## 15B Failure Modes and Effects Analysis (FMEA)

The information in this appendix of the reference ABWR DCD, including all subsections, tables, and figures, is incorporated by reference with the following departures.

STD DEP T1 3.4-1 (Table 15B-3)

STD DEP 7.7-1 (Figure 15B-1)

Figure 15B-1 Simplified CRD System Process Flow Diagram

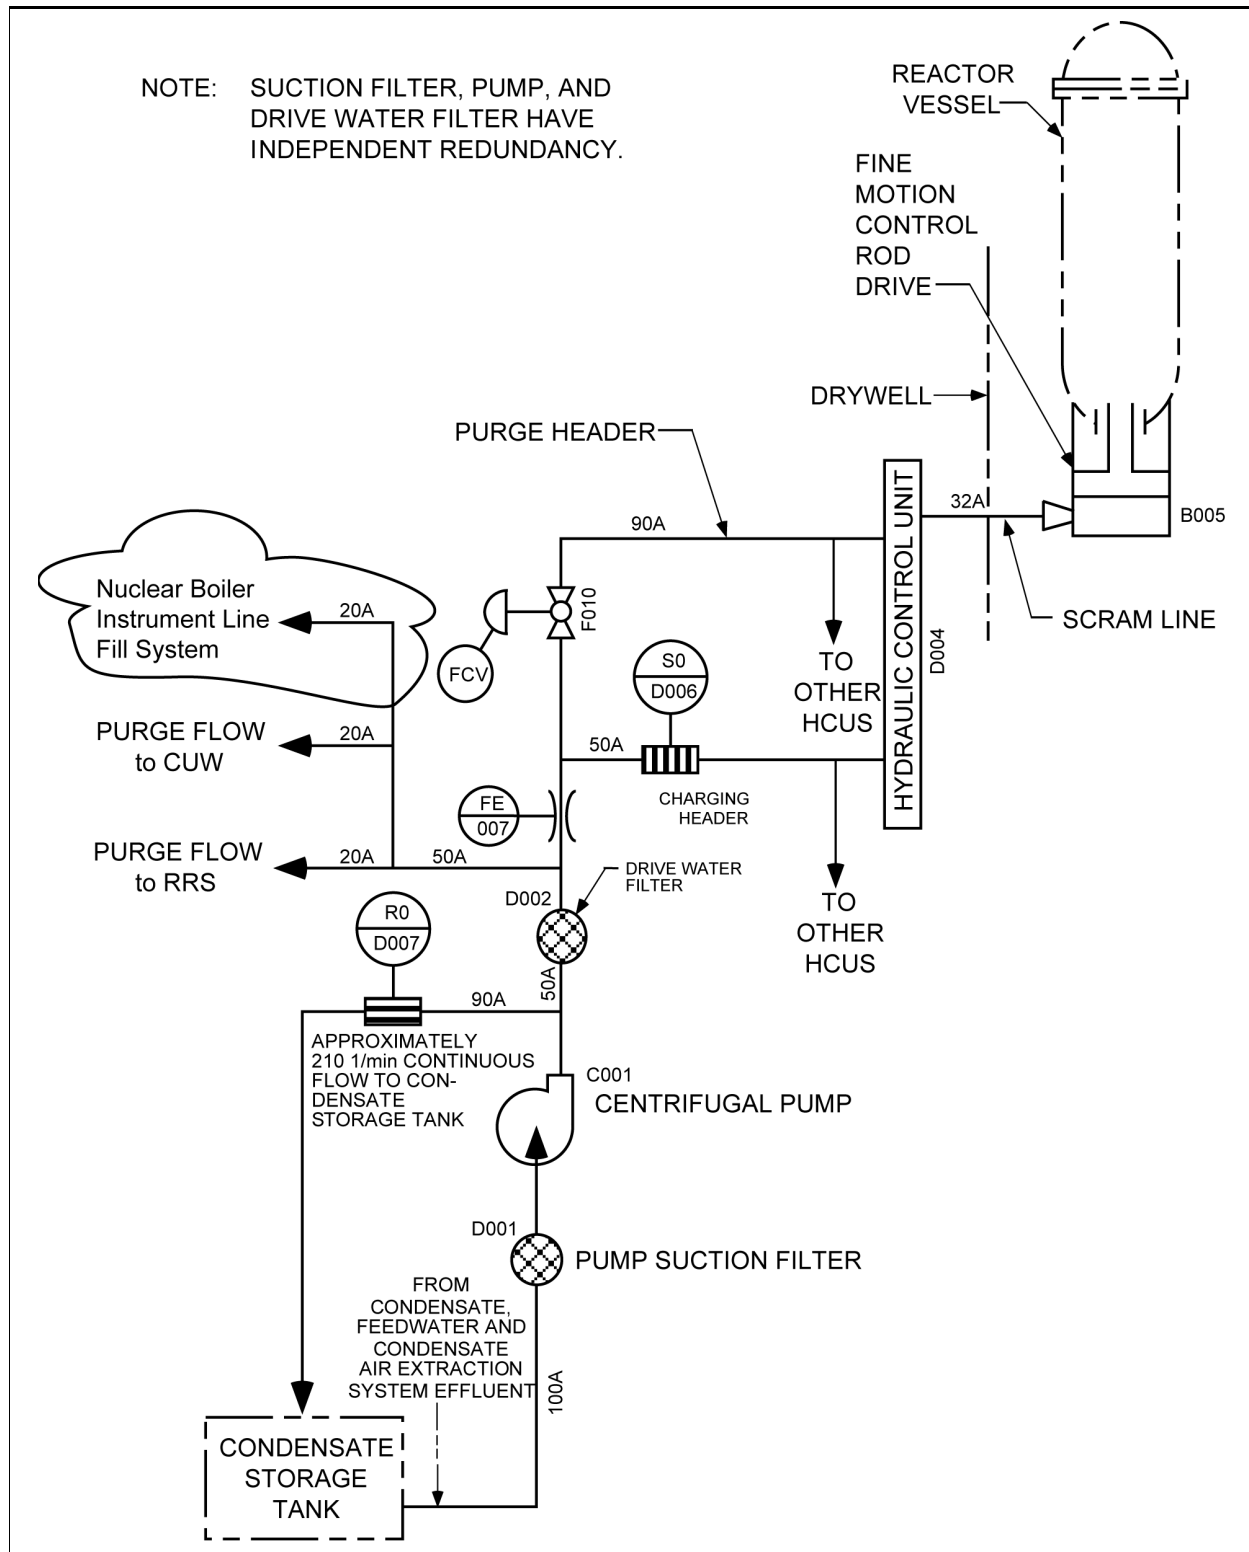
STD DEP 7.7-1

*A simplified CRD System process flow diagram is shown in Figure 15B-1. CRD System water is taken from the condensate, feedwater and condensate air extraction system, or Condensate Storage Tank (CST) through a suction filter by a centrifugal pump and discharged through a drive water filter to the HCU. (During shutdown the CST is the primary source.) Each of these components is independently redundant and only one of each is in operation at any one time. A portion of the pump discharge flow is diverted through a minimum flow bypass line to the CST. The pumped water is directed to the HCU to provide hydraulic scram and to furnish purging to the drive. This system also provides purge water for the reactor internal pumps, nuclear boiler instrument lines, and the reactor water cleanup pumps.*
